From: Bernard, Dana
Sent: Friday, March 15, 2019 10:02 AM
To: mbholsinger@comcast.net
Subject: FW: 1450 Long Corner Road

RE: B18002782
1450 Long Corner Road
Mount Airy, MD 21029

This letter is in response to building permit **B18002782**. The existing system is considered inadequate for your proposed addition. To get started, percolation testing must occur on the property. Please submit a percolation test application, percolation test plan and fee of \$506 to the Health Department. The homeowner will be responsible for hiring an engineer to create a percolation test plan and a septic contractor with a backhoe to dig the percolation test holes.

ON SITE SEWAGE DISPOSAL SYSTEM DESIGN PLAN
LANDS CONVEYED TO
ROY A. SKAHILL, JR.

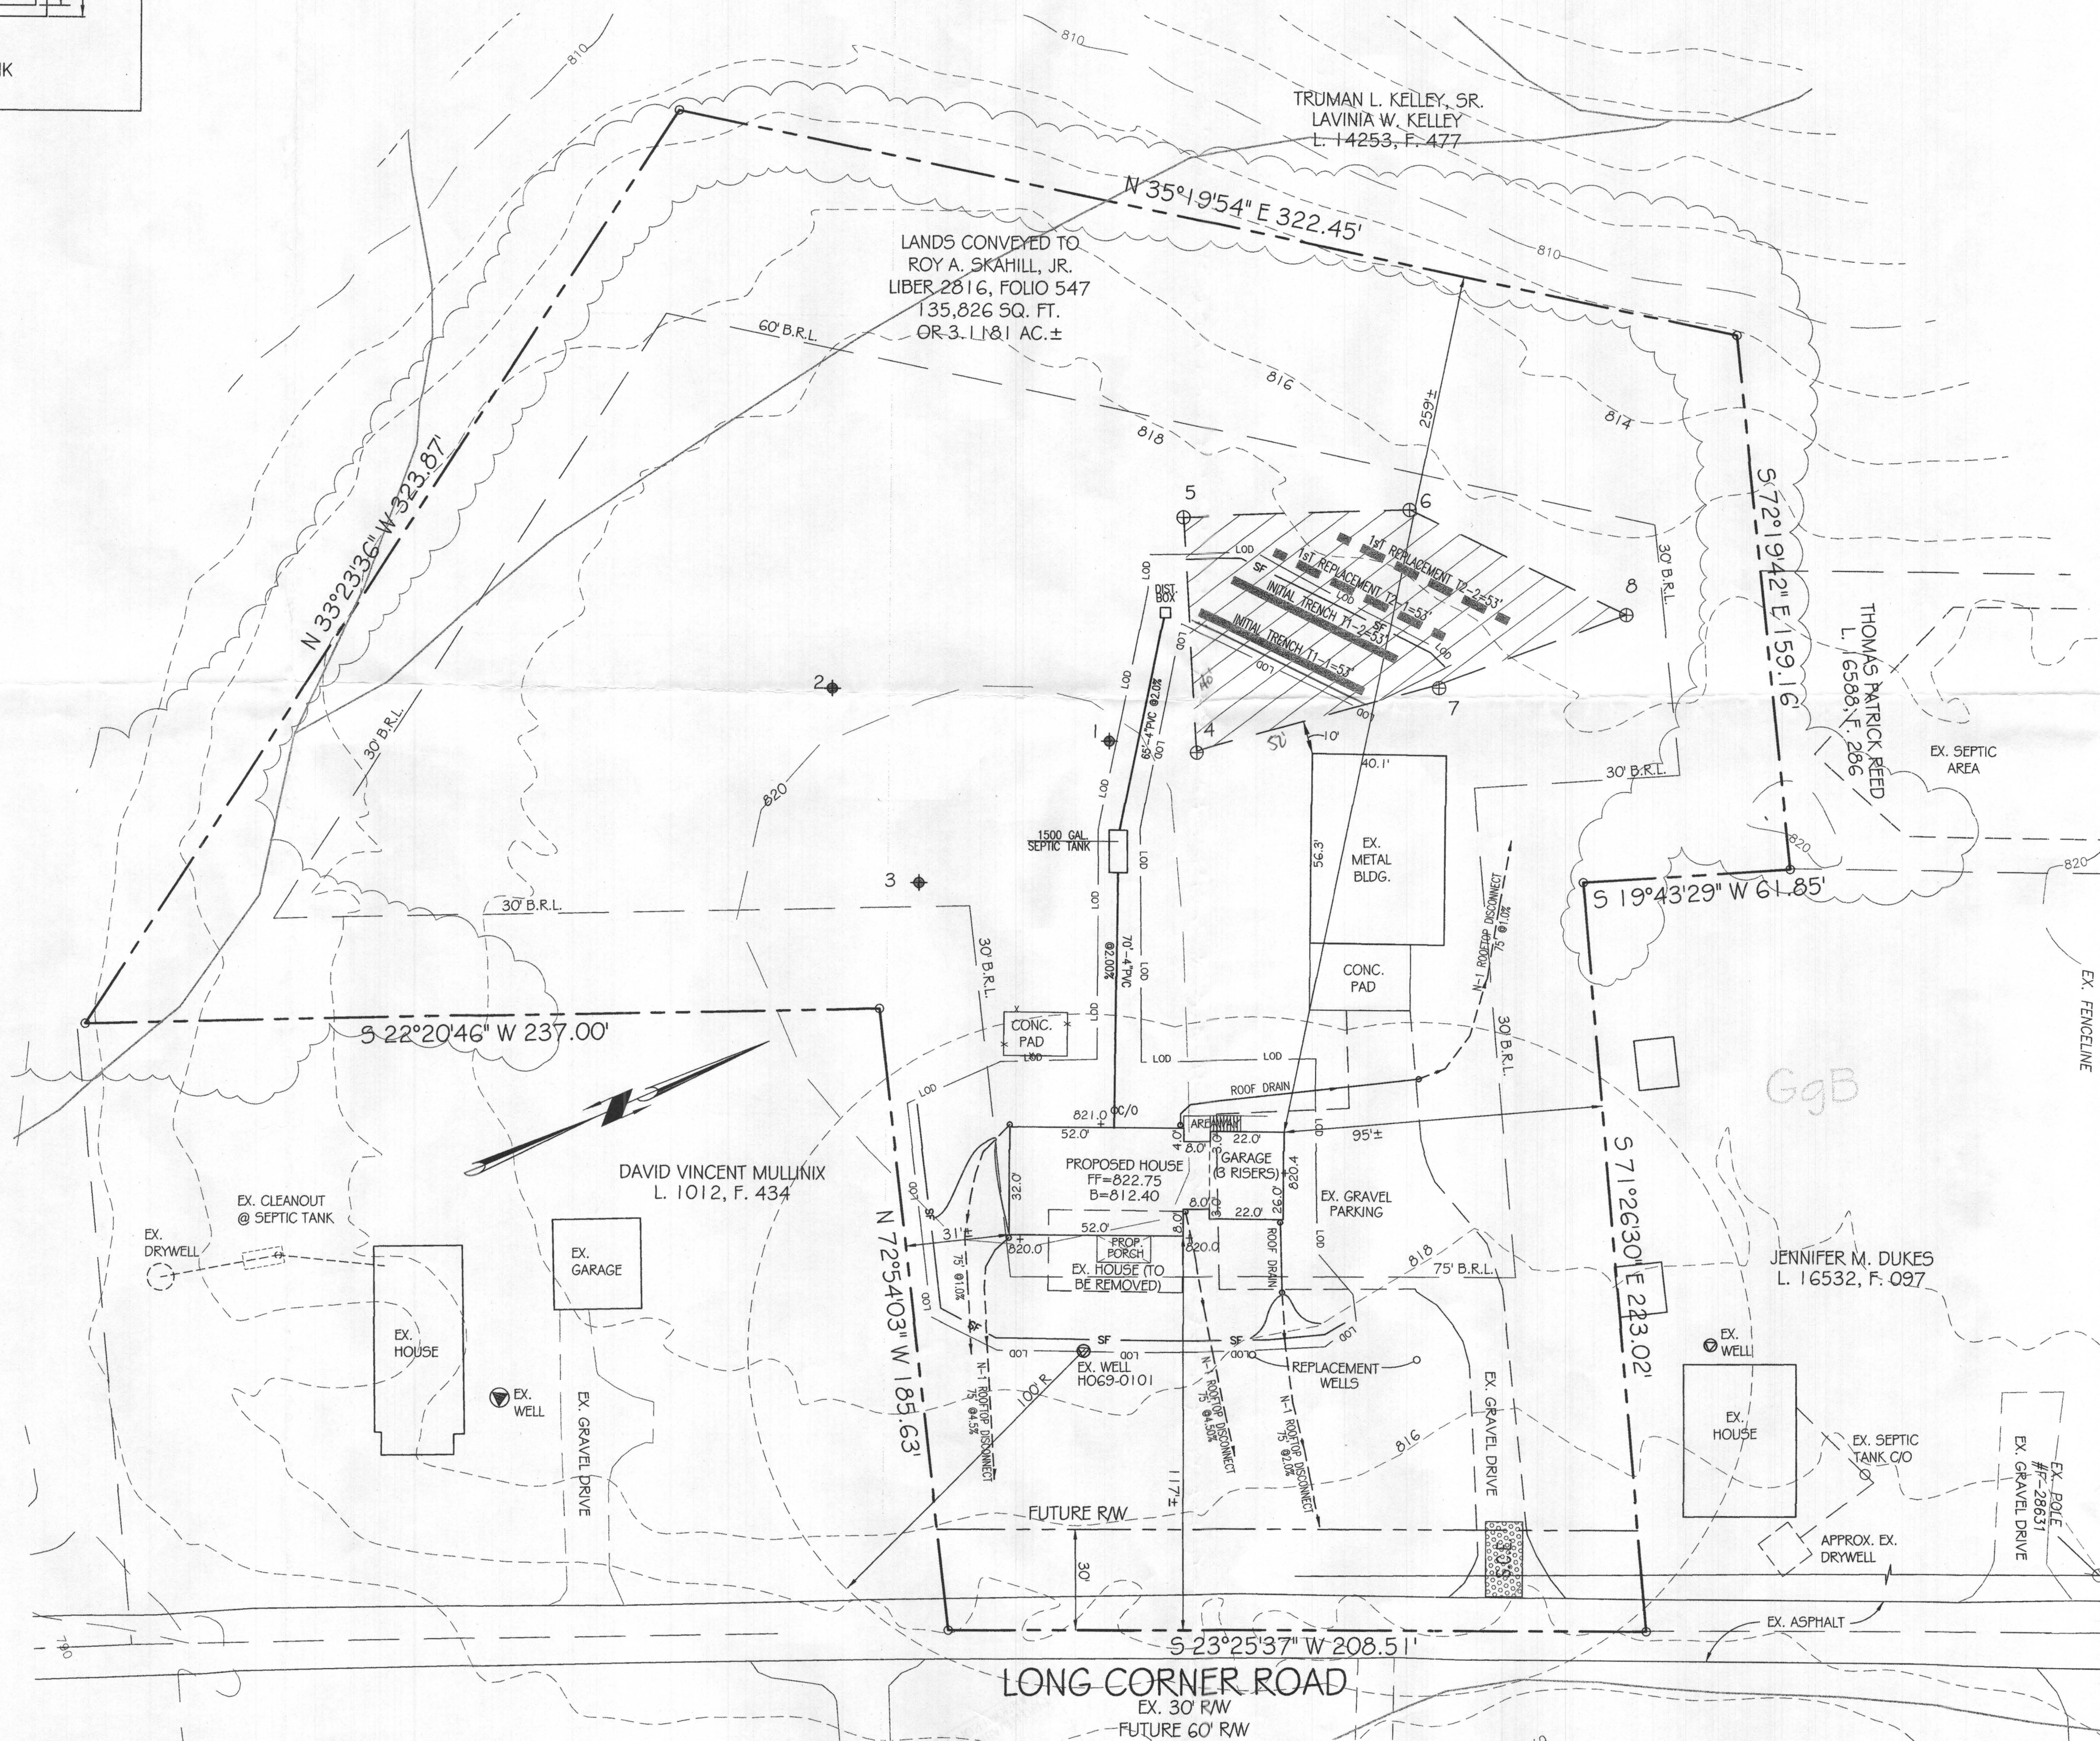
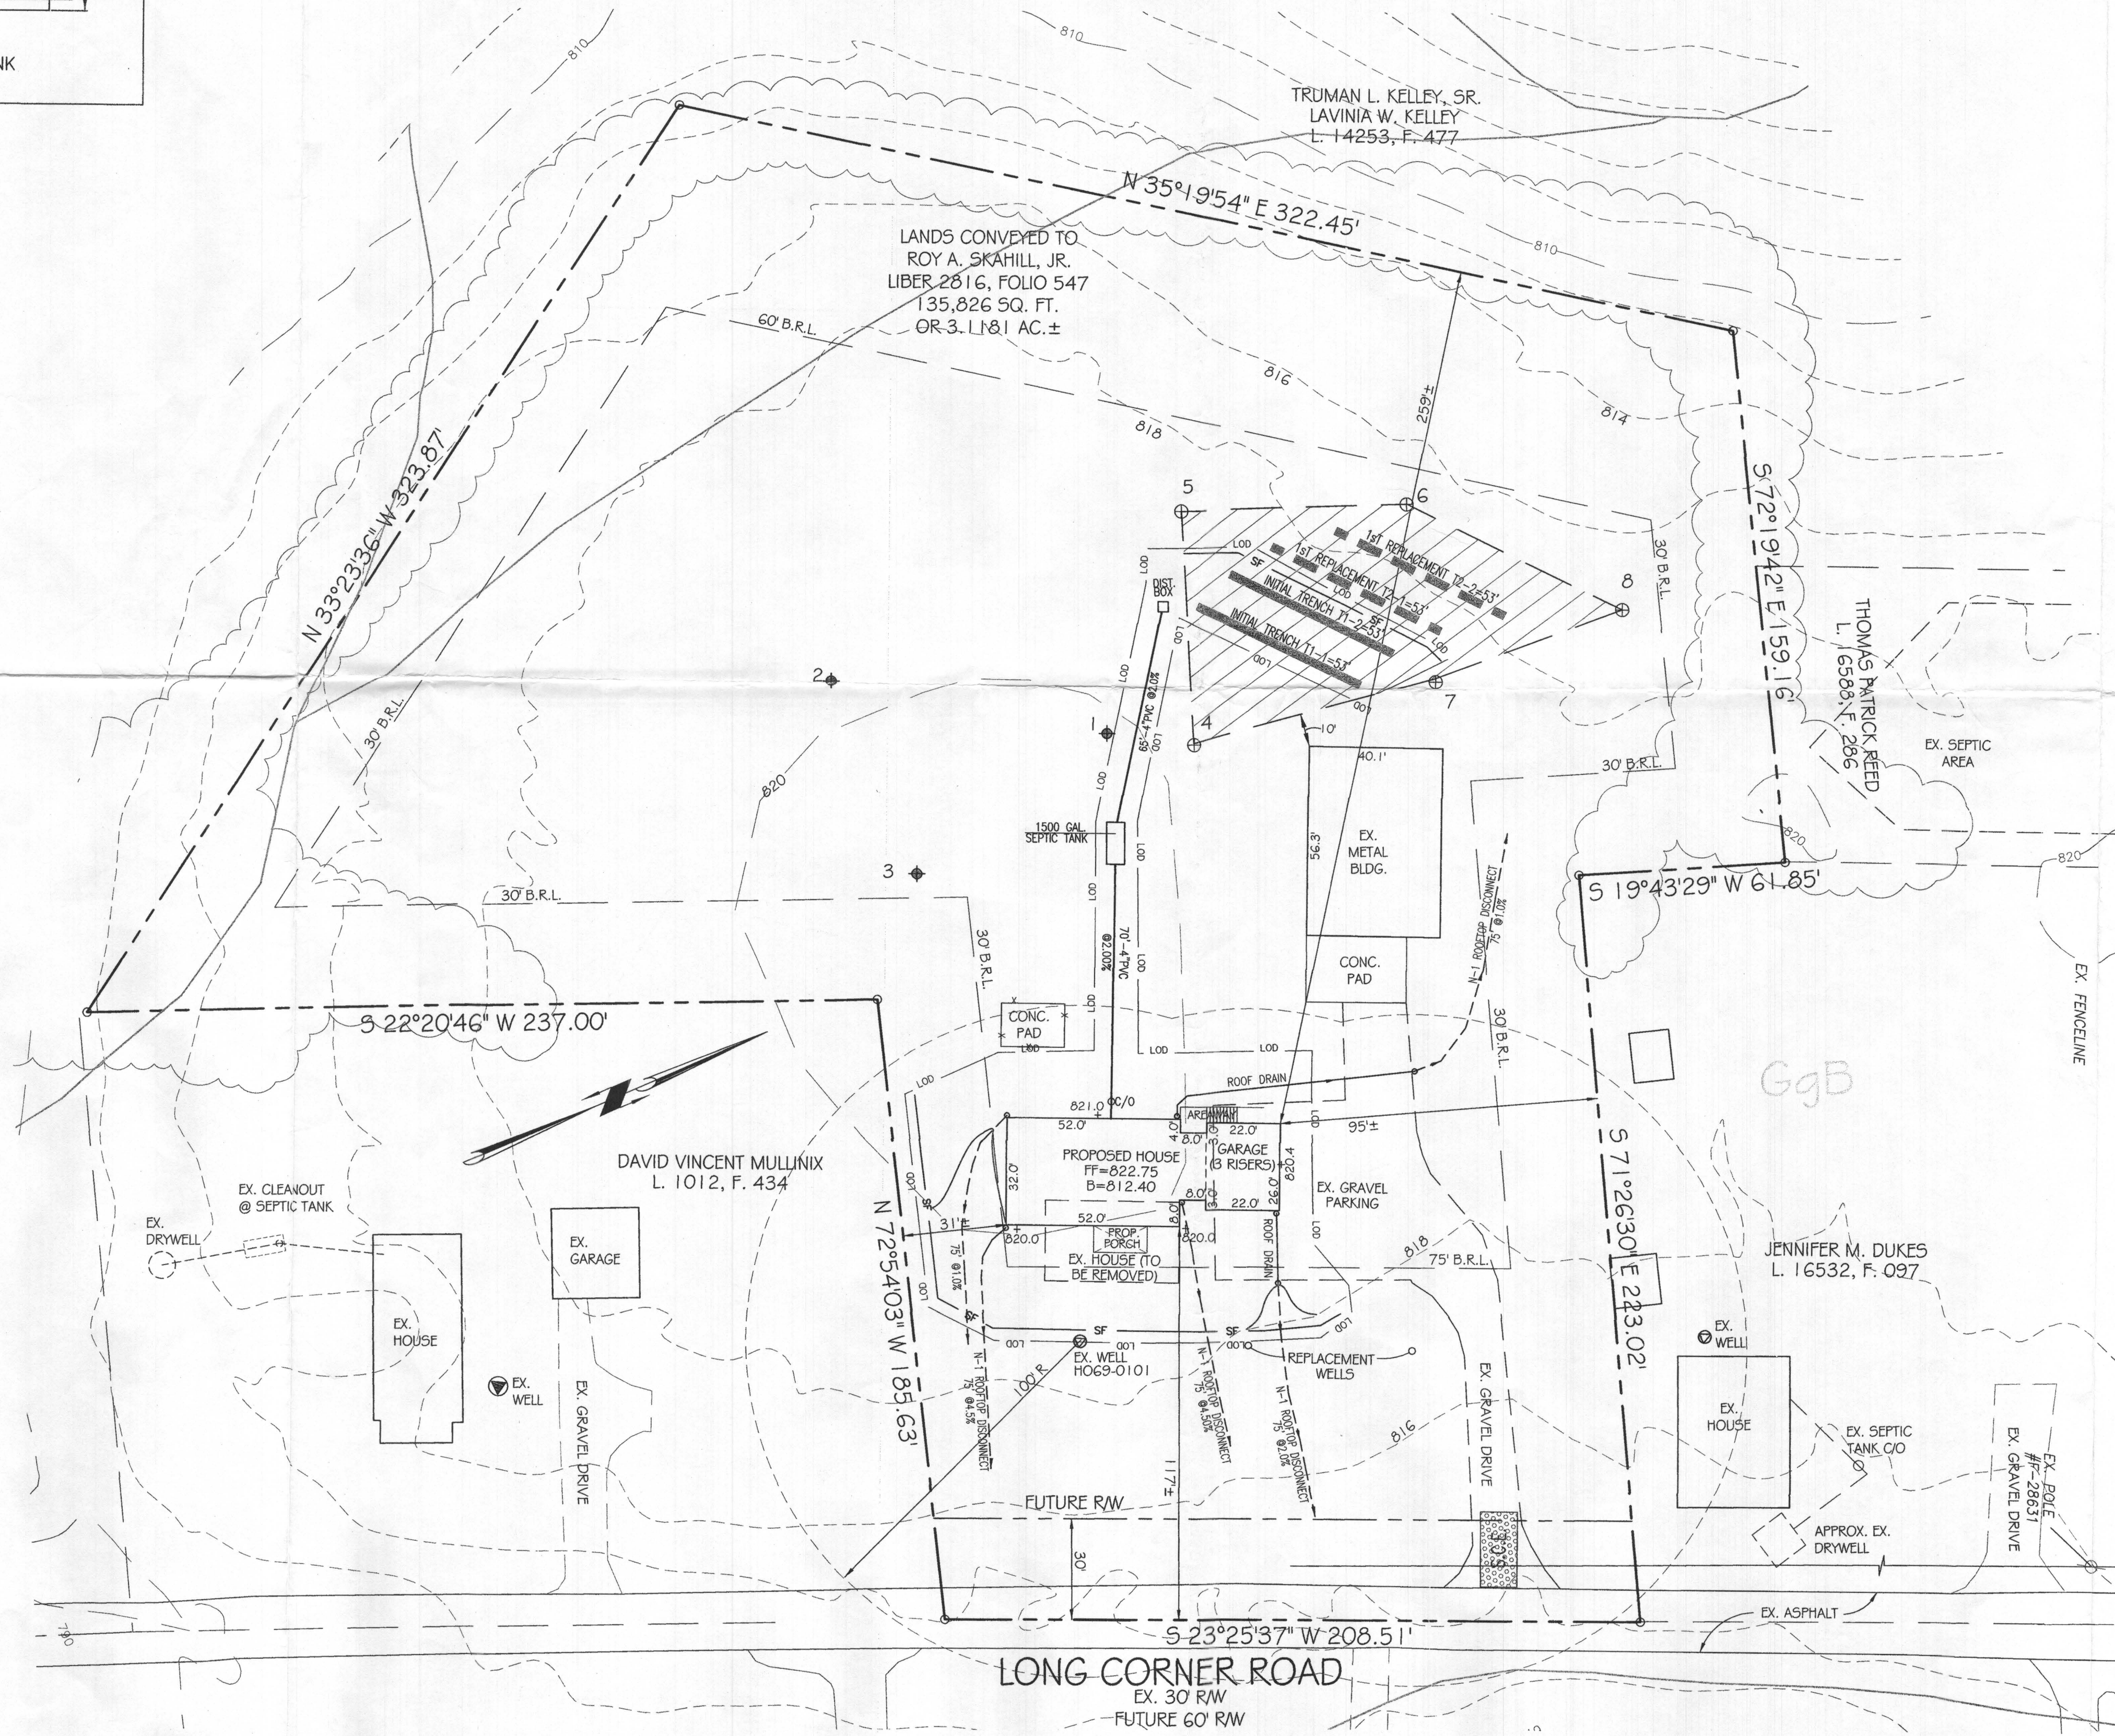
Once the testing is completed a sewage disposal area (SDA) for the proposed house and future repairs must be established on a percolation certification plan." Since a percolation certification plan does not exist for this property, it will have to be created prior to building permit approval (Howard County Code Sec 3.805).

If the onsite well does not meet current regulations, it will have to be brought up to code prior to approval of a building permit. For example, if the well does not have casing extending above grade, the well casing must be extended by a licensed well driller with a pit less adaptor installed. Furthermore, if the well doesn't meet the required 20 foot setback to the house with basement, then the owner will have to ask for a Variance from the Maryland Department of the Environment (MDE) and receive approval prior to making any changes to the well. Please revise site plan to show all septic system components (per As-Built drawing).
